## Product Change Notice

Design related: minor design change of duplex connector cable

HFBR-RSD001Z  
HFBR-RSD002Z  
HFBR-RSD005Z  
HFBR-RSD25DZ

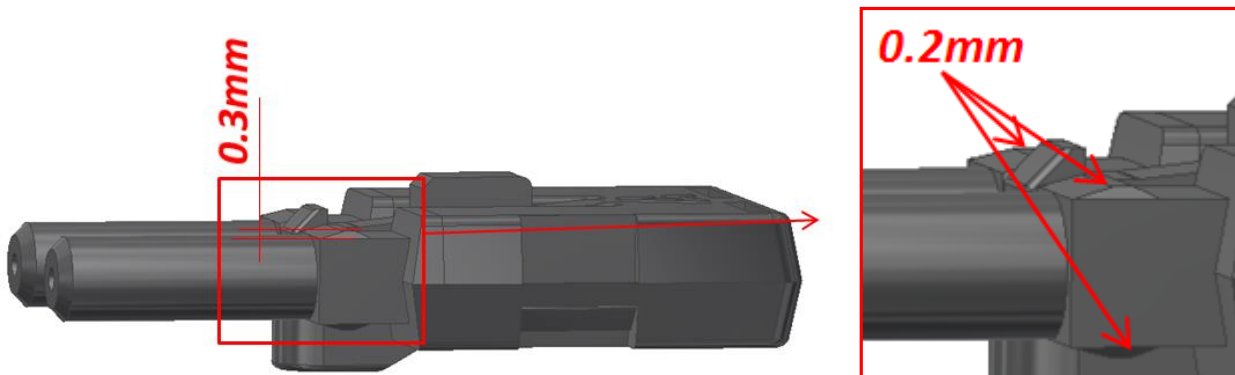
Reduction of ridge-height, details see below pictures. The connector material remains unchanged.

Reduce height of ridges from 0.3mm to 0.2mm

Connector the housing retention force is too high when latch is pressed down. Therefore it is difficult to unplug connector from versatile link housing. The reduction of the thickness reduces the necessary force to unplug the connector.
